# Oregon State University

## FAIRBANKS HALL 4<sup>TH</sup> FLOOR RENOVATION CONSTRUCTION SERVICES

**ITB #2024-014680**

### **ADDENDUM NO. 3**

### 1 | DOOR TYPES

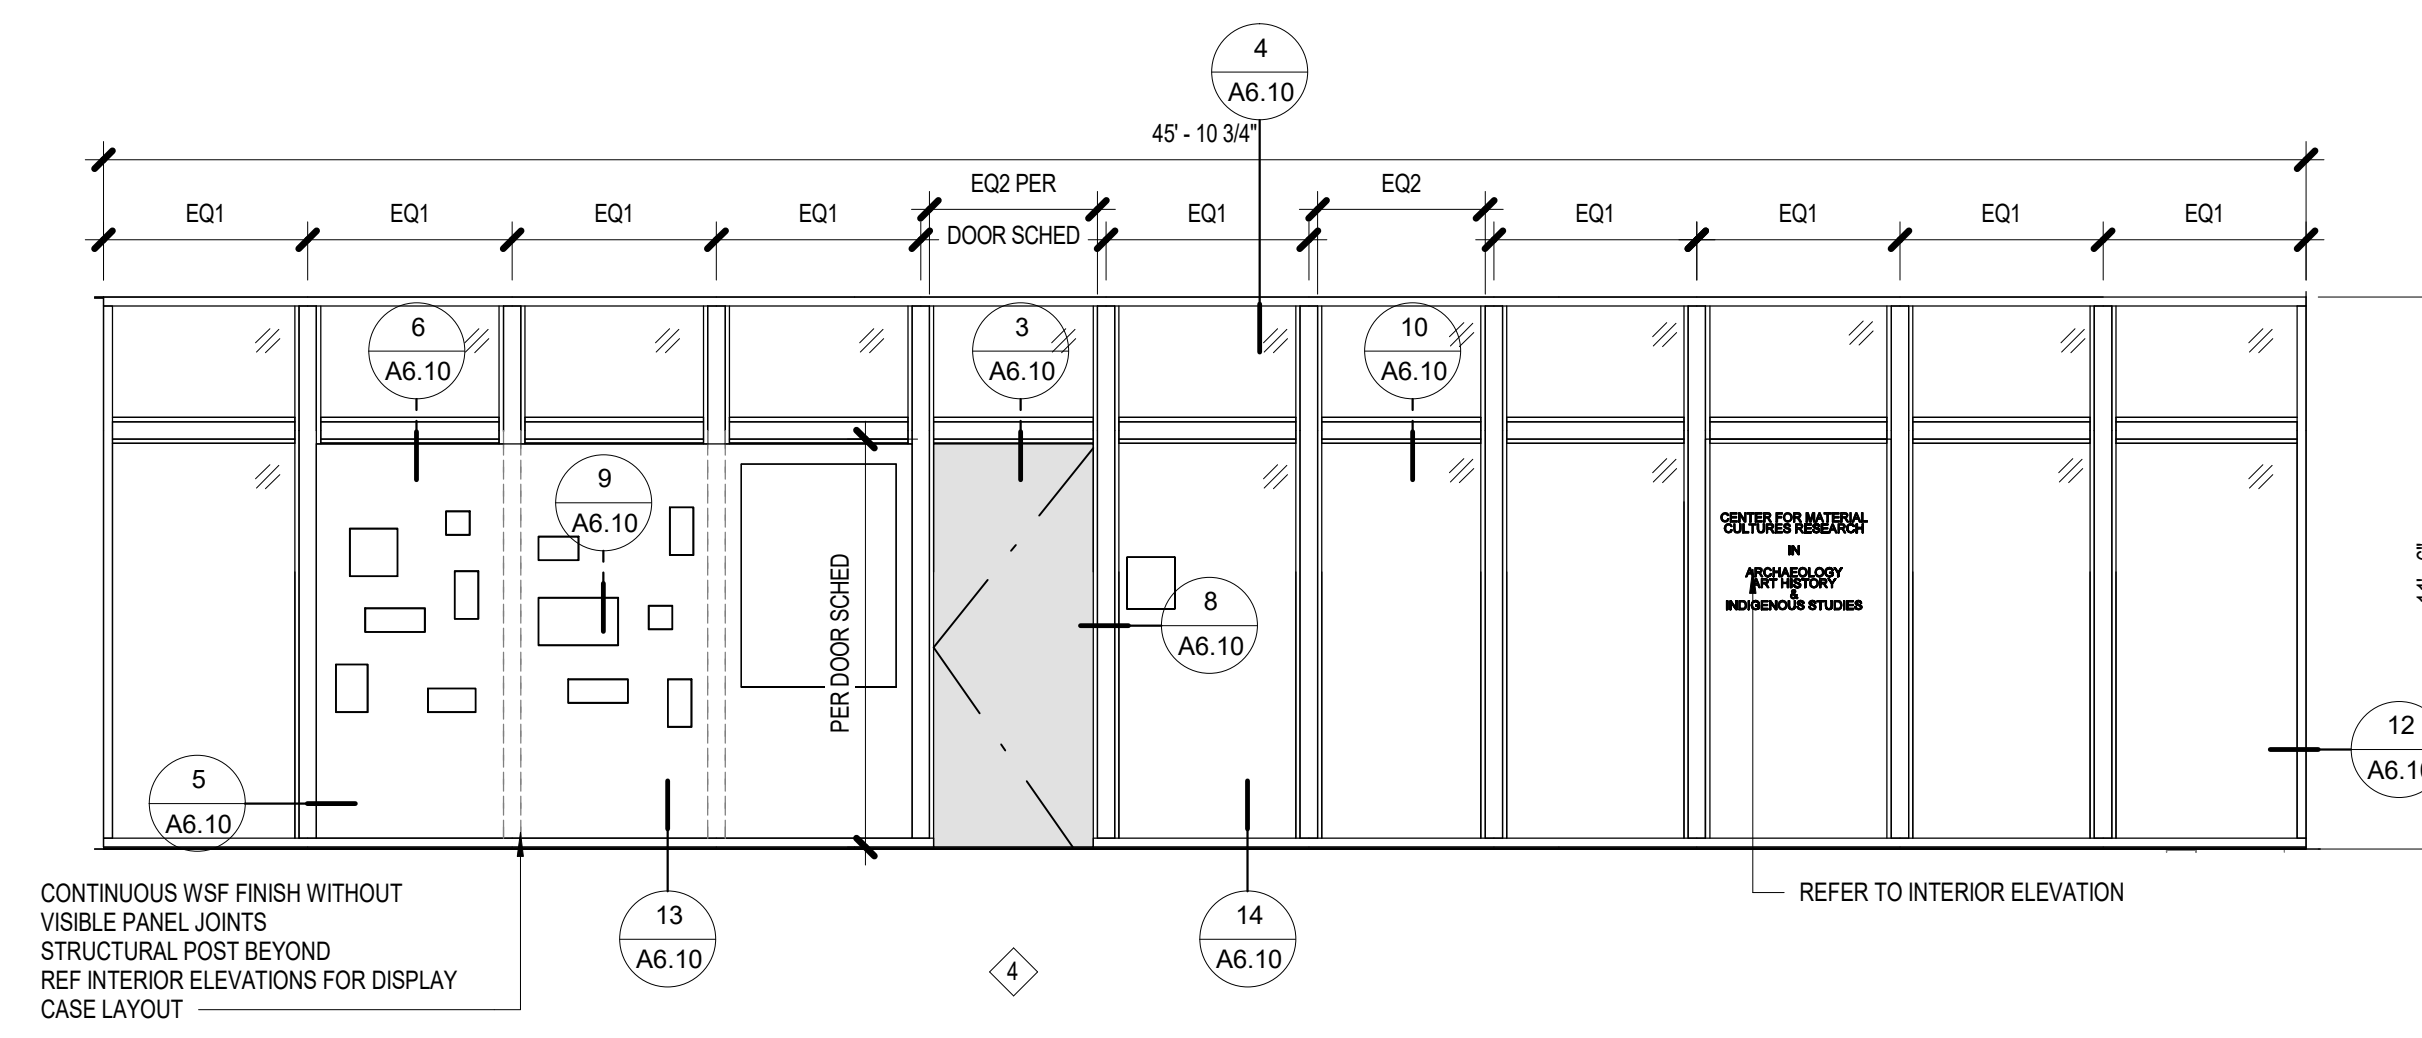
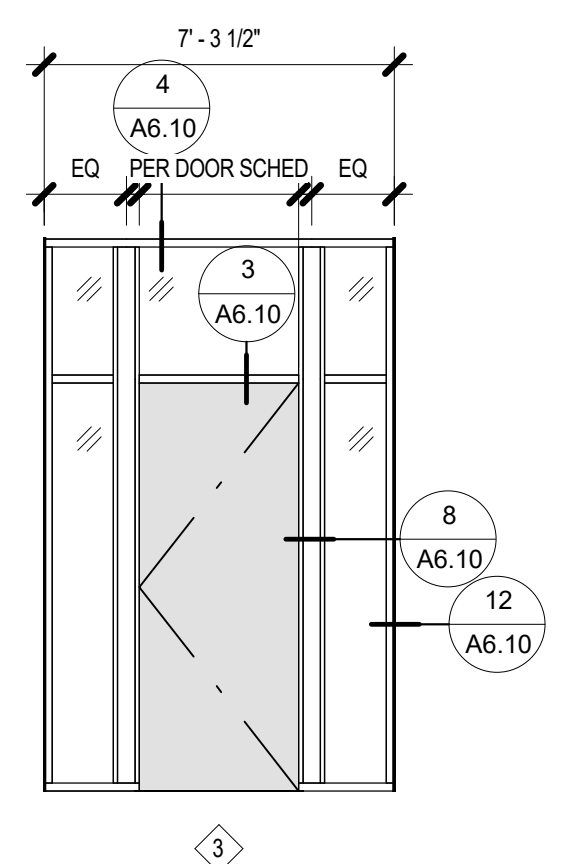
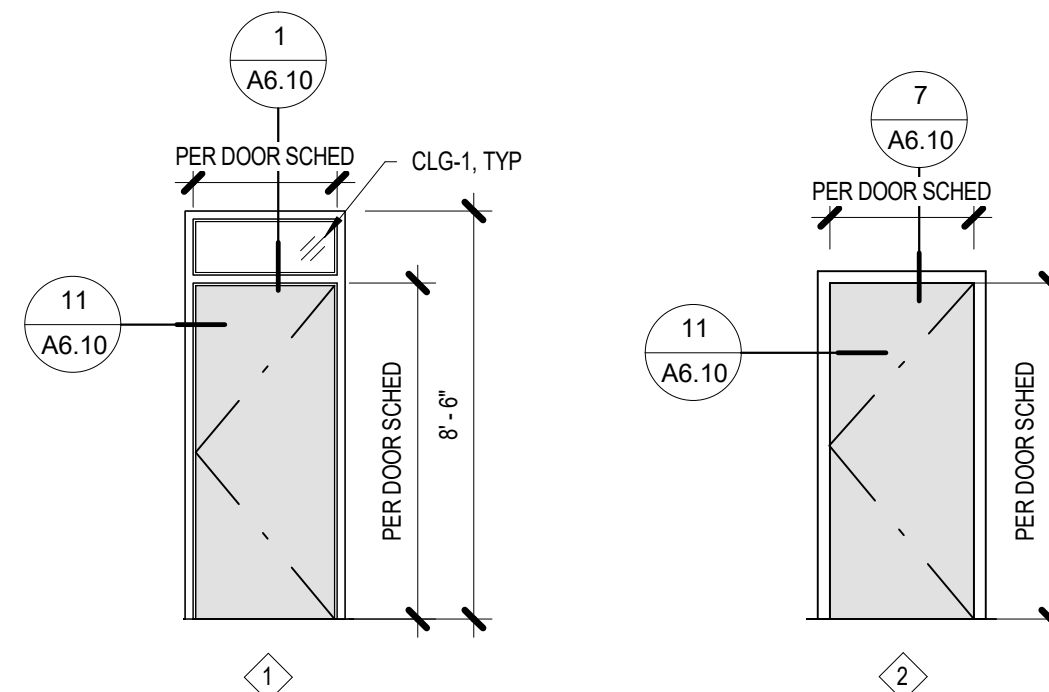
10	Schedule 2 – Window Types/A0.70 Note 2, and Note 17/AD1.13, AD1.14, AD1.15 (Level 3 Demo, Level 4 Demo, Roof Demo) indicate to remove integral blinds from all existing windows. Clean Glazing and Screen. Please confirm this note is applicable only at 4th floor where work is occurring.	Confirmed.
12	The door shown between Archaeology 427 and Hallway H433 is noted on sheet A1.10 as opening #424-1. Door #424-1 is also shown as the entry into Storage 424. Is the door between Archaeology 427 and Hallway H433 supposed to instead be opening #427-1 (not currently used elsewhere)?	Confirmed, door to Archaeology 427 should be tagged 427-1 on A1.10.
13	The door hardware specifications indicate use of the Schlage L-series full mortise locks into the new SRWD-1 doors. The door schedule also indicates that these doors are to have 5" width rails. The L-series full mortise lock bore depth into the stile for prep will impact the door panel due to the narrow 5" stile width. Please confirm if a different hardware type should be accounted for, or if wider 6" stiles would be acceptable to accommodate the scheduled locks.	Provide 6" stiles to accommodate specified door hardware as indicated on revised A0.70 sheet provided with Addendum 3
